# PARTS BULLETIN

**Subject: Optional Extended Ramp Kit for Rotary Four Post Lifts**

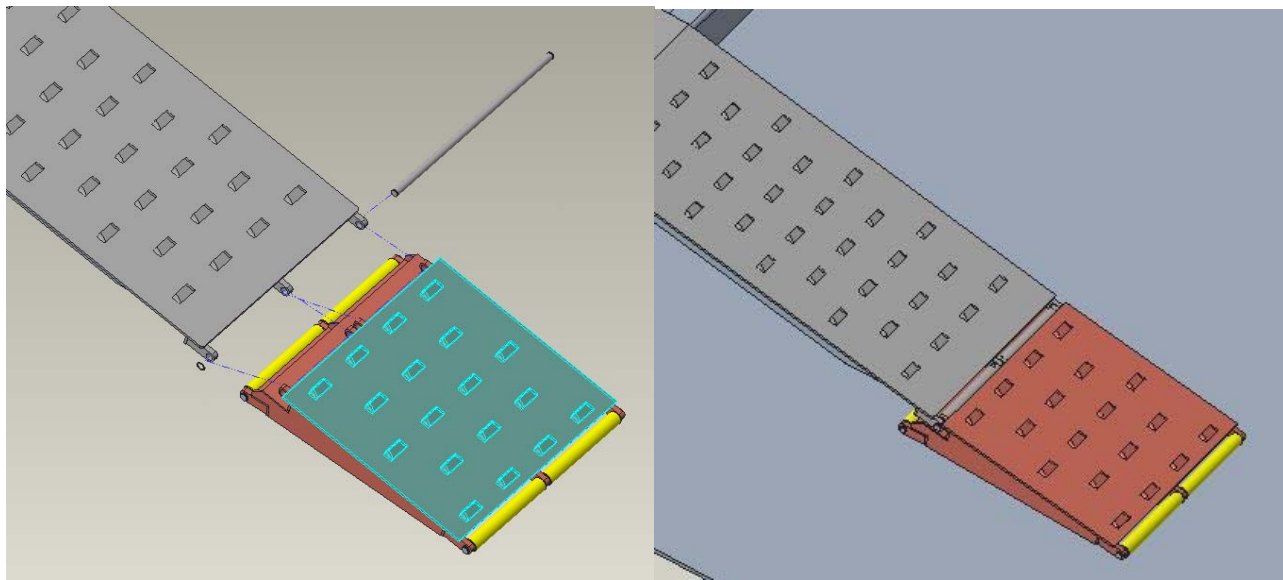
Please be advised that a new optional extended ramp kit has been developed for the Rotary four post lift range to reduce runway approach angle and help lift lower vehicles.

The new kit part number is SM14-05KIT1, which includes 2x SM14-05EEL-00 ramp extensions.

The new extension has a length of 597.2mm and reduces the approach angle from 10 deg to 7.2 deg.

This accessory can be installed with the standard ramp kit S110405Y on the lifts: AR14, ARO14, SM14, SMO14.
